ArevaEPRDCPEm Resource

From: WILLIFORD Dennis (AREVA) [Dennis.Williford@areva.com]
Sent: Wednesday, August 10, 2011 4:36 PM
To: Tesfaye, Getachew
Cc: BENNETT Kathy (AREVA); DELANO Karen (AREVA); ROMINE Judy (AREVA); RYAN Tom (AREVA); NOXON David (AREVA)
Subject: Response to U.S. EPR Design Certification Application RAI No. 273, FSAR Ch 11, Supplement 16
Attachments: RAI 273 Supplement 16 Response US EPR DC.pdf

Appended to this file are affected pages of the U.S. EPR Final Safety Analysis Report in redline-strikeout format which support the response to RAI 273 Questions 11.05-2, 11.05-5, 11.05-7, 11.05- 8, 11.05-9, and 11.05-10.

Figure 9.4.3-2—Nuclear Auxiliary Building Air Supply and Exhaust Subsystem

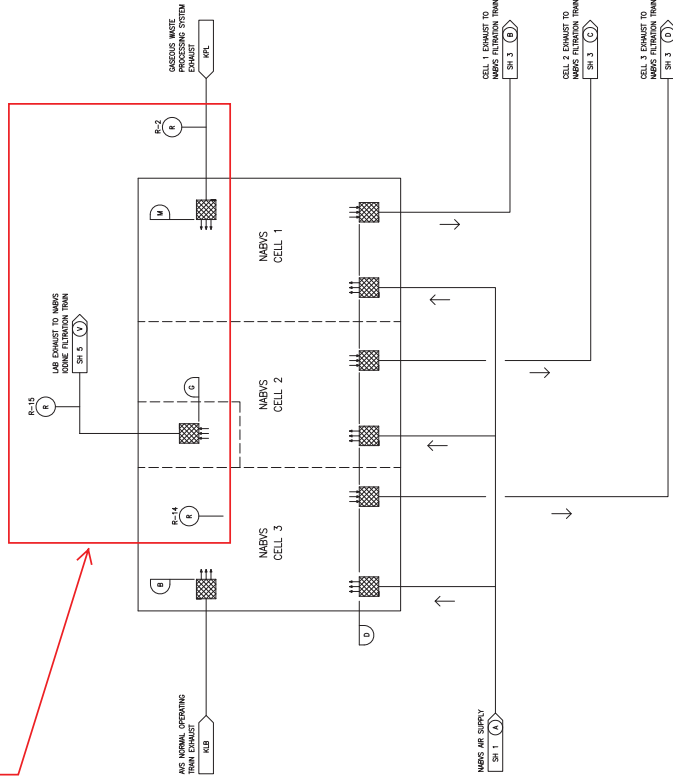
- 6) For the Nuclear Auxiliary Building exhaust, Figure 9.3.4-2 shows a radiation detector on the ductwork going into Cell 1 of the NABVS but it is not clear if this radiation detector is an extra one or is it the same as that shown in Figure 11.3-1 given its location.

- 7) Figure 9.3.4-2 shows a radiation detector in Cell 3 of the NABVS but it is not clear if this radiation detector is part of an existing PERMSS subsystem and not described in FSAR Sections 11.5 and 9.4.3, or is part of another system, such as used for monitoring ambient airborne radioactivity levels in radiological controlled areas.

RAI 273,
Q. 11.05-2

Figure 9.4.5-2—Safeguard Building Controlled-Area Ventilation System Exhaust Air Subsystem

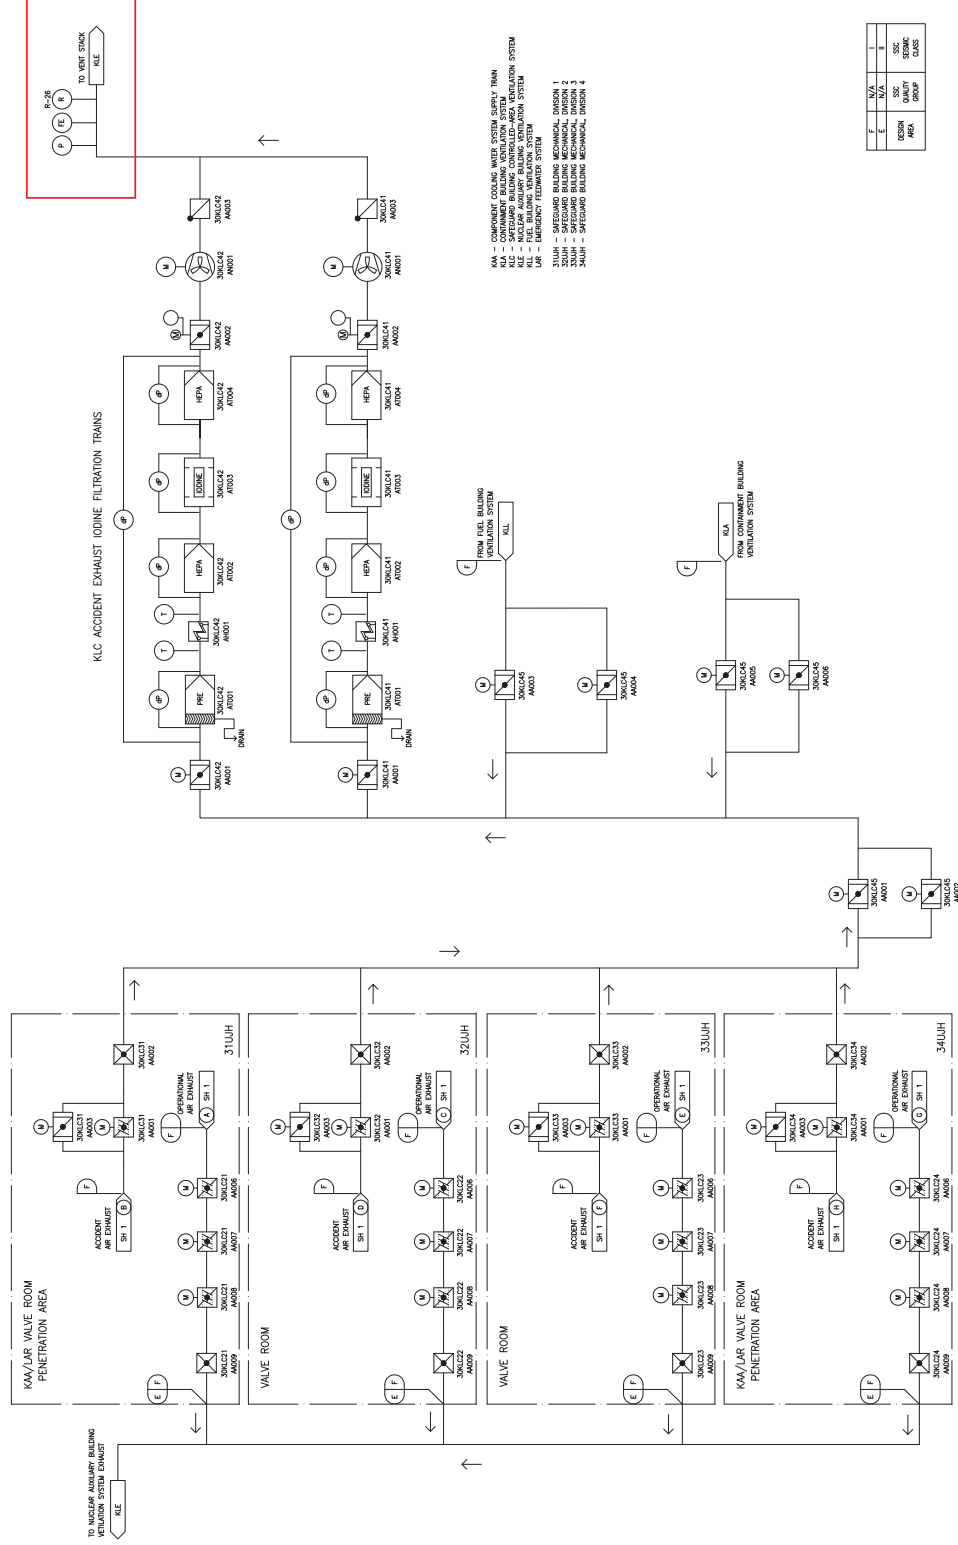
- b. Although FSAR Table 11.5-1 identifies the use of a multi-function process radiation monitor, its location could not be readily determined in FSAR Figure 9.4.5-2. Accordingly, Figure 9.4.5-2 should be reviewed to confirm whether its location is indicated and, if not, it should be added to the figure to ensure a complete representation of the system.

RAI 273,
Q. 11.05-2

Figure 9.4.8.2—Radioactive Waste Building Ventilation System Exhaust Air Station

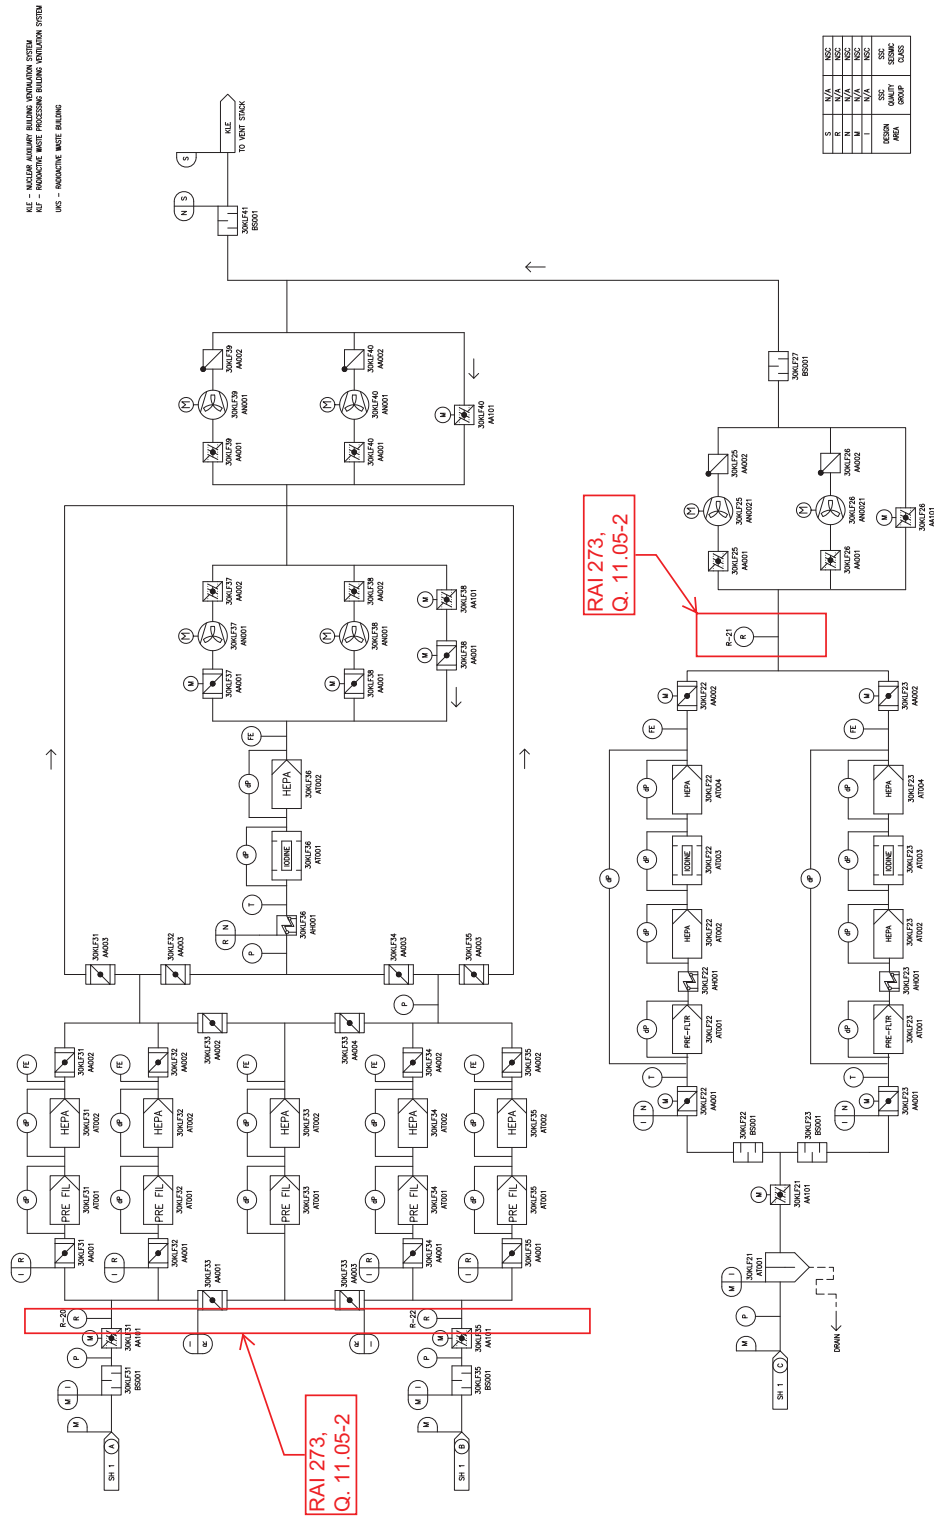
- b. Based on a review of FSAR Sections 11.5 and 9.4.8 figures and descriptions, it is not clear if a radiation detector is missing or one needs to be relocated in Figure 9.4.8-2 on the line coming from the RWBVS Processing Rooms (Line C from Sheet 1 to Sheet 2). In contrast, the corresponding lines from RWBVS Cells 1 and 2 show a radiation detector for Lines A and B from Sheet 1 to Sheet 2 before the filter trains. Accordingly, FSAR Sections 11.5 and 9.4.8 should be reviewed and revised to ensure a consistent presentation of design and operational features in understanding how RWBVS radiation monitors function and alert operators when effluent releases could exceed the effluent concentration limits of Appendix B to Part 20.

- c. In FSAR Table 11.5-1, the entry for the RWBVS radiation monitoring system indicates that there are two iodine radiation monitors and four aerosol radiation monitors. A review of FSAR Figures 11.5-1 and 9.4.8-2 indicates that the placements of these monitors is not clear given that there are three input flows to the RWBVS exhaust, one for Cell 1 and one for Cell 2 (Lines A and B from Sheet 1 to Sheet 2), and one for the RWBVS Processing Rooms (Line C from Sheet 1 to Sheet 2). There is no rationale provided for having one set of radiation monitors before each particulate/charcoal train for Cells 1 and 2 vent exhausts and none after it, and no explanations for the placement of the Processing Rooms monitor after the particulate/charcoal train with none before it. Accordingly, FSAR Sections 11.5 and 9.4.8 should be reviewed and revised to provide the technical rationale for the placement of radiation monitoring instrumentation in ensuring that effluent releases do not exceed the effluent concentration limits of Appendix B to Part 20.

U.S. EPR FSAR Tier 2, Section 9.4.8, Table 11.5-1, and Figure 9.4.8-2 will be revised as described in the response to this question provided in RAI 273, Supplement 4 and indicated on the enclosed markup.

Figure 11.5-1—Radioactive Effluent Flow Paths With Process and Effluent Radiation Monitors

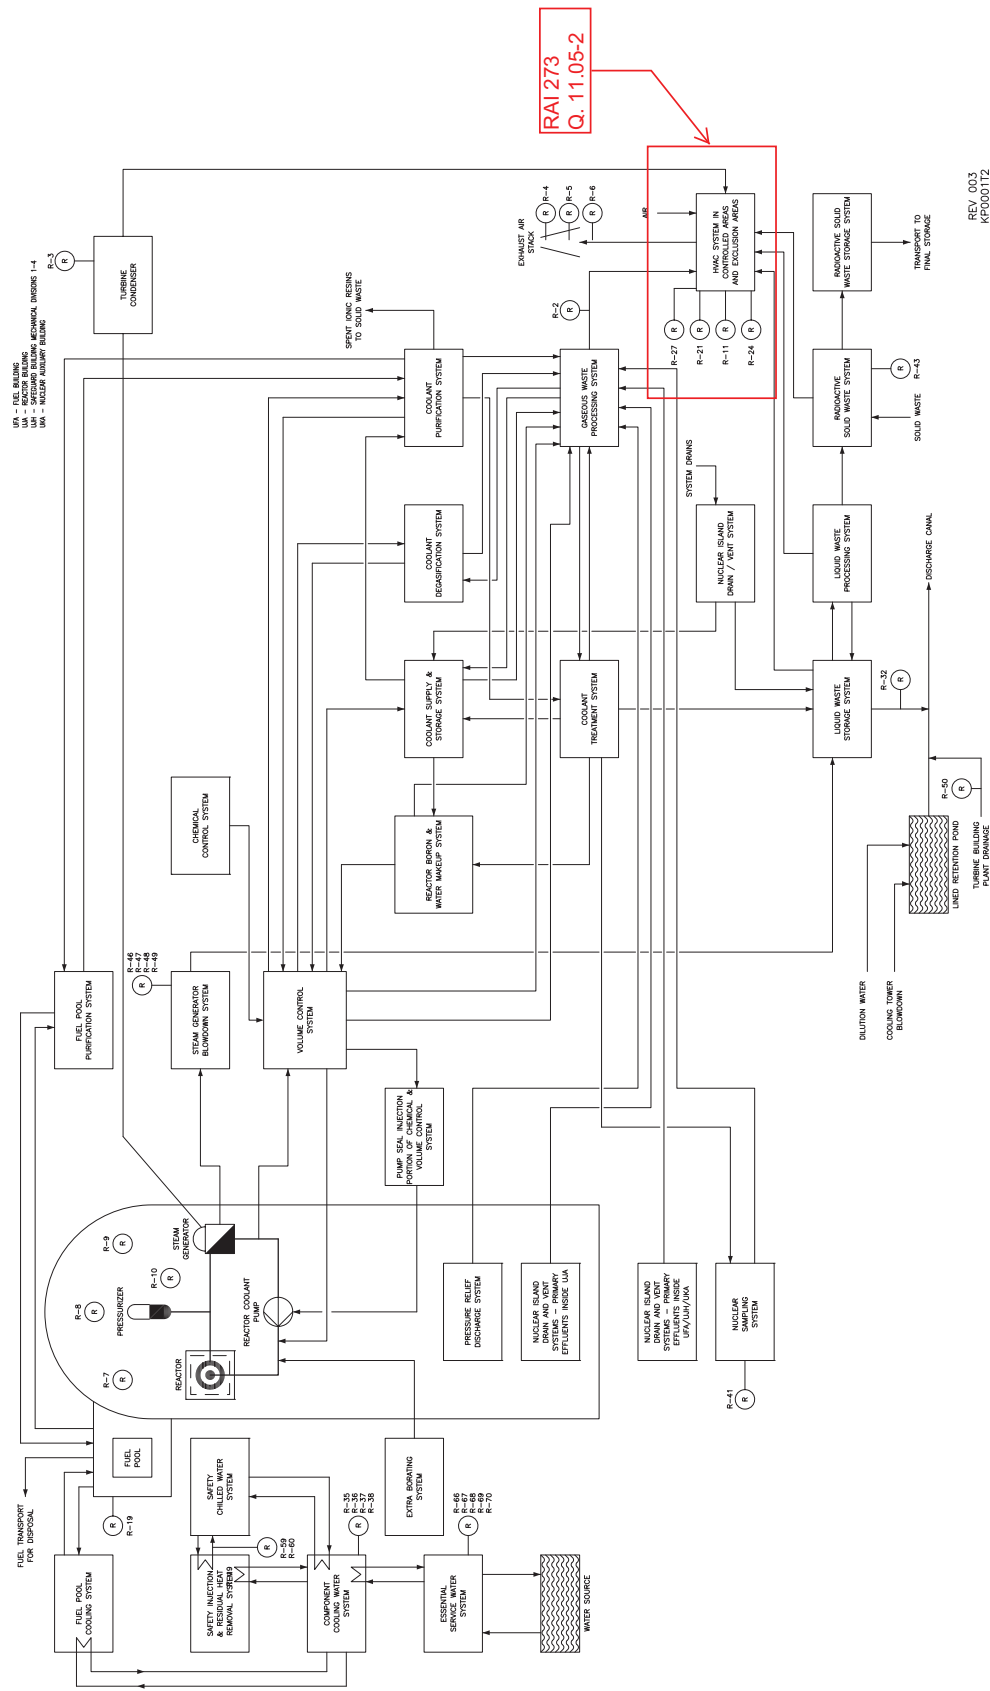
- 10) FSAR Figure 11.5-1 shows a radiation monitor on the Turbine Building Plant drainage line, but this monitor is not listed in FSAR Table 11.5-1.
